BULLETIN

NUMBER 151

SUBJECT: Elevator Push-Pull Tube Rollers

MODELS AFFECTED: PA-23 Apaches - Serials 23-1 to 23-903 inclusive

ELE. PUSH/PULL TUBE ROLLER	
SKETCH 'A'	S.B. 151
PIPER AIRCRAFT CORP.	
LOCK HAVEN, PA.

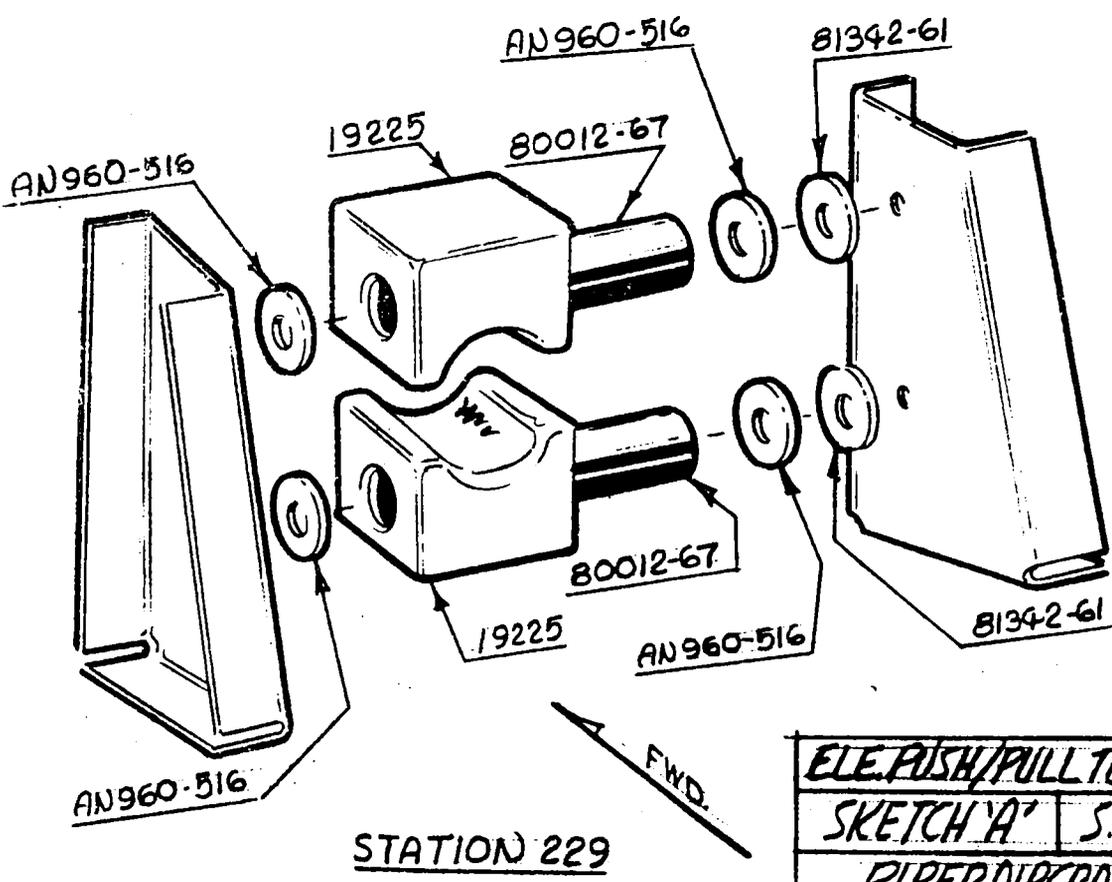
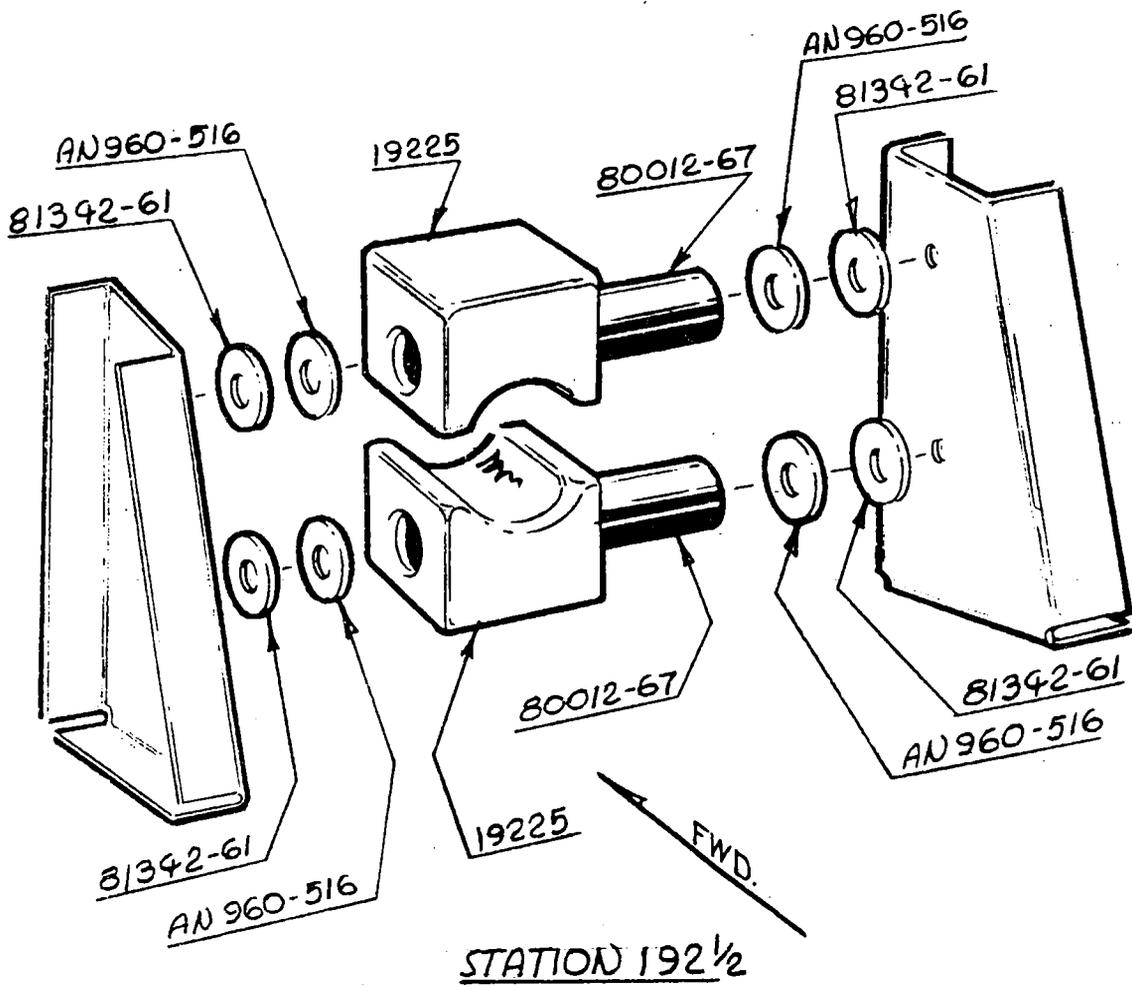
Service reports from our "Certified Service Centers" indicate that the elevator push-pull tube in the Apache is wearing at a point where it passes through the fiber rollers. This problem has been eliminated in production by the installation of nylon blocks in place of the fiber rollers.

It is requested that four (4) each of block, part number 19225-00, be obtained and installed per Sketch "A" shown on the reverse side of this Bulletin. Compliance with this Bulletin is required at the next 100 hour inspection or by May 1, 1957, whichever shall occur first. Careful examination should be made of the wear area on the elevator push-pull tube and any tube that shows wear exceeding .005 inches should be replaced. The four bearings 80012-67 and the six washers 81342-61 should be removed from the fiber roller installation and reused in the nylon block installation. The AN960-516 washers and the blocks 19225-00 are the new parts required.
